Link Union Station

Response to Comments

October 2025

Figure 2. N Main St is included in the *Mobility Plan 2035* as a Protected Bicycle Lane Street (left), Pedestrian Enhanced District (center), and a Moderate Transit Enhanced Street (right).

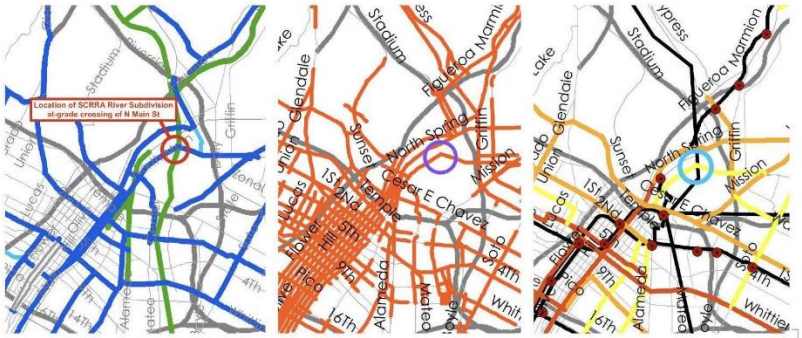
The LinkUS DEIR proposes a reconfiguration of the N Main St at-grade crossing with an 8 ft wide median up to 100 ft to the east and west of the tracks **(Figure 1)**. However, the proposed changes will conflict with active transportation infrastructure upgrades outlined in the *Mobility Plan 2035* and this conflict is not addressed in the DEIR. N Main St is a designated Tier 1 Protected Bike Lane on the Bicycle Enhanced network and is a designated Pedestrian Enhanced District. It is also a Moderate Transit Enhanced Street on the Transit Enhanced Network **(Figure 2)**.

Based on the comments received from Streets for All, the 8-foot-wide median at North Main Street has been removed from the current design. Final EIS/SEIR Chapter 2.0, Figure 2-27 has been revised to reflect the latest design of the safety improvements at the North Main Street at-grade public crossing for the Build Alternative. Final EIS/SEIR Chapter 9, Figure 9-17 also depicts the latest design of the safety improvements at the North Main Street at-grade public crossing for the Build Alternative Design Option. The current design is at a preliminary level and proposed in accordance with CPUC regulations to maximize safety by prohibiting vehicular traffic from crossing into opposite lanes of traffic within the vicinity of the at-grade railroad crossing. As discussed in the Final EIS/SEIR Section 3.14, a safety assessment was completed for the Project that focused on pedestrian/bicycle safety conditions near the existing rail alignment and at the one the at-grade crossing where proposed improvements would occur (North Main Street). The proposed safety improvements

Figure 3. The LinkUS proposed median does not permit minimum upgrades to N Main St as outlined in the *Mobility Plan 2035*.

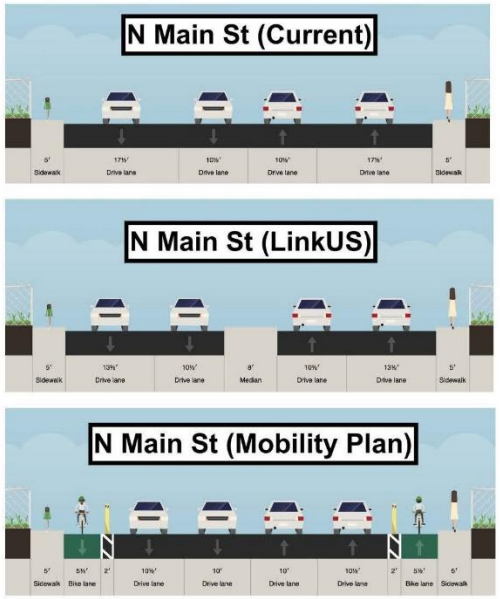
The N Main St ROW is approximately 66 feet wide at the bridge with curb-to-curb width of 56 feet **(Figure 3)**. The addition of an 8 foot median with four 10-11 foot vehicle travel lanes would occupy 48-52 feet of ROW. This leaves only 4 to 8 feet of ROW for bicycle facilities. Protected one-way bicycle facilities will require approximately 16 feet, while a two-way cycle track will require approximately 12 feet of ROW. Protected bicycle facilities may barely fit on the bridge without the addition of the median when maintaining two travel lanes. Additionally, the sidewalk widths of ~5 feet are substandard and would possibly require sidewalk widening as part of the pedestrian enhanced district improvements. Finally, removal of a travel lane will likely conflict with the road's designation as a Moderate Transit Enhanced Street. A different solution will likely be needed to comply with these planned upgrades, which are now mandated by Measure HLA. Some potential options may include N Main St bridge widening/reconstruction, grade separation, or more substantial revision of traffic patterns.

Figure 1. Current Link US without the Loop Track leads to a significant limitation of through-running Metrolink Services.

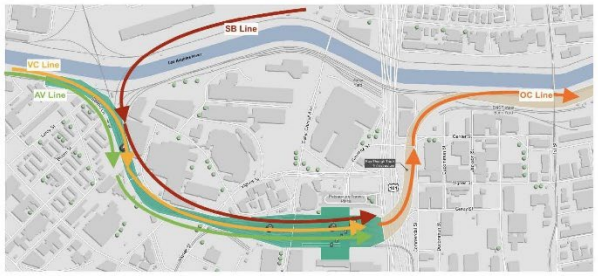
Even prior to any other structures, the loop track would allow VC or AV Line trains planned to through-run onto the SBL to continue on the River subdivision past Union station, and enter LAUS from the south on the Loop track in a clockwise fashion (**Figure 2**). This circuitous route is still far quicker than transferring at Union Station. Due to the current flat junction of the SB Line and River subdivision on the western bank of the LA river, this temporary pattern would require schedule planning, but due to the low frequency planned for the Riverside Line from time-slot limitations, conflicts would be rare. With a new crossing of the LA River for the SB Line near Caesar Chavez, it would be able to enter Union station from the south (**Figure 3**). This arrangement maximizes efficiency for Union Station and Metrolink.
